**ADDENDUM #1**

**May 3, 2024**

**PROJECT: DHDS/BRPD UP1 ROOF REPLACEMENT  
CITY PARISH PROJECT NO. 21-ASC-CP-1521**

**3 DESIGN WIND LOAD DIAGRAM**

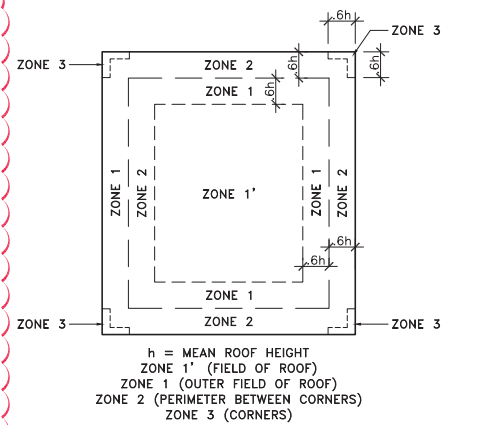
11. Specification Section 01 0000, "City Parish Summary of Work", Section 1.04.F.1, delete "**One Thousand Dollars (\$1000)**", substitute "**Seven Hundred Dollars (\$700)**".
12. Specification Section 01 0000, "City Parish Summary of Work", Section 3.06. Delete this section in its entirety.
13. Specification Section 07 7100, "Sheet Metal Flashing and Trim", Section 2.7.B.1, delete "...20 gauge...", substitute "...22 gauge...".
14. Project Information, Title Sheet, drawing Sheet T1.1. Delete "C-P Project No: 22-ASD-CP-1351", substitute "C-P Project No: 21-ASC-CP-1521".
15. Drawing 1, "Wind Load Analysis", Sheet A4.1. Delete this drawing in its entirety, replace with the attached revised Sheet A4.1.

- C. Changing the bid date.
  - D. Deleting the City required job sign from the project.
  - E. Replacing sheet A4.1 to update the wind loading pressures.

I WIND - LOAD ANALYSIS		
ROOF	WIND PRESSURES	MINIMUM WIND UPLIFT RATINGS
A B C 128' X 366'-0"	ZONE 1 = +10.17 PSF -39.69 PSF	ZONE 1 = +21.00 PSF -80.00 PSF <span style="color:red">▲</span>
	ZONE 1' = +10.17 PSF -22.80 PSF	ZONE 1' = +21.00 PSF -50.00 PSF
	ZONE 2 = +10.17 PSF -52.40 PSF	ZONE 2 = + 21.00 PSF -110.00 PSF
α: 14.0 FEET	ZONE 3 = +10.17 PSF -71.42 PSF	ZONE 3 = + 21.00 PSF -145.00 PSF
	ZONE 1 = +10.17 PSF -39.69 PSF	ZONE 1 = +21.00 PSF -80.00 PSF
	ZONE 1' = +10.17 PSF -22.80 PSF	ZONE 1' = +21.00 PSF -50.00 PSF
D & E 158'-0" X 82'-0"	ZONE 2 = +10.17 PSF -52.40 PSF	ZONE 2 = + 21.00 PSF -110.00 PSF
	ZONE 3 = +10.17 PSF -71.42 PSF	ZONE 3 = + 21.00 PSF -145.00 PSF
	ZONE 1 = +10.17 PSF -39.69 PSF	ZONE 1 = +21.00 PSF -80.00 PSF
α: 14.0 FEET	ZONE 1' = +10.17 PSF -22.80 PSF	ZONE 1' = +21.00 PSF -50.00 PSF
	ZONE 2 = +10.17 PSF -52.40 PSF	ZONE 2 = + 21.00 PSF -110.00 PSF
	ZONE 3 = +10.17 PSF -71.42 PSF	ZONE 3 = + 21.00 PSF -145.00 PSF
